4 Ms. Lisa Orsaba, CEQA Project Manager, Energy Division
5 California Public Utilities Commission
6 c/o Ecology and Environment, Inc.
7 505 Sansome Street, Suite 300
8 San Francisco, CA 94111
9 Email: Mesa.CPUC@ene.com

11 ***Re: SCE's Comments on the Draft Environmental Impact Report (SCH #2015061014)***
12 ***for the Mesa 500 kV Substation Project (A.15-03-003)***

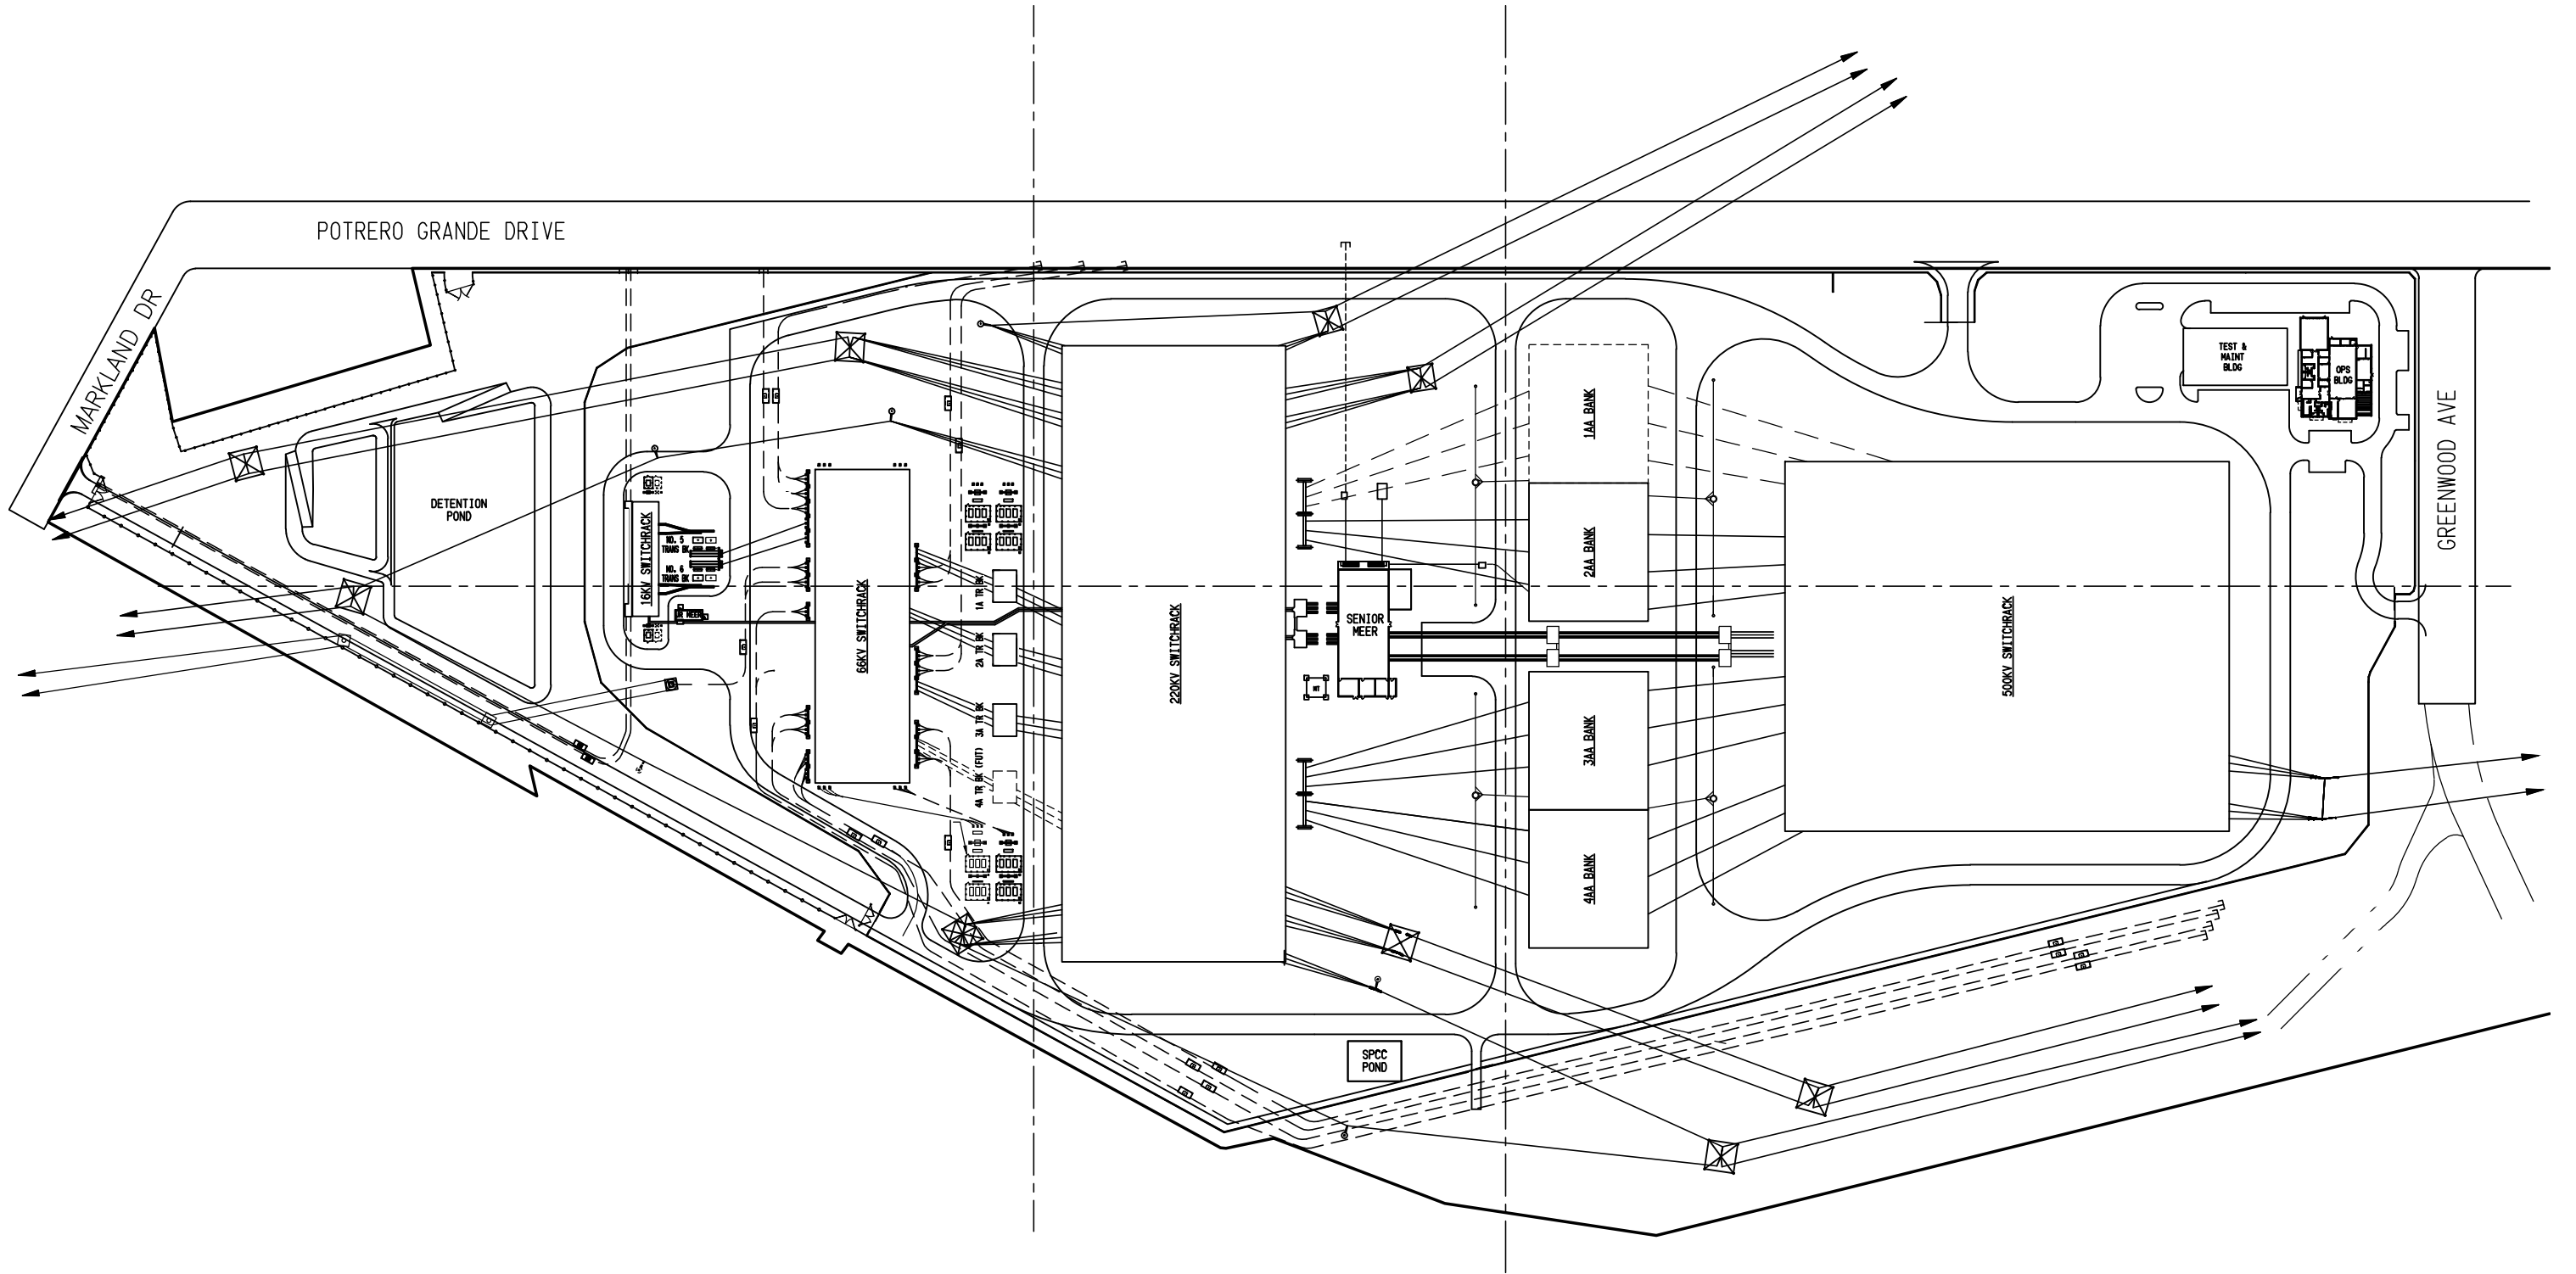
2.2.1.1	2-29, Figure 2-4	Figure 2-4 Proposed Mesa Substation Layout	<p>Rationale:</p> <p>Please replace the existing Figure 2-4 Proposed Mesa Substation Layout with the updated figure attached to this submittal, which more accurately reflects the current engineering design for the substation as well as the other linear elements. In particular, this design reflects the proper location of the relocated Operations Building and the Test and Maintenance Building closer to Greenwood Avenue.</p> <p>SCE recommends the following edits:</p> <p>Replace current Figure 2-4 Proposed Mesa Substation Layout with attached updated figure.</p>
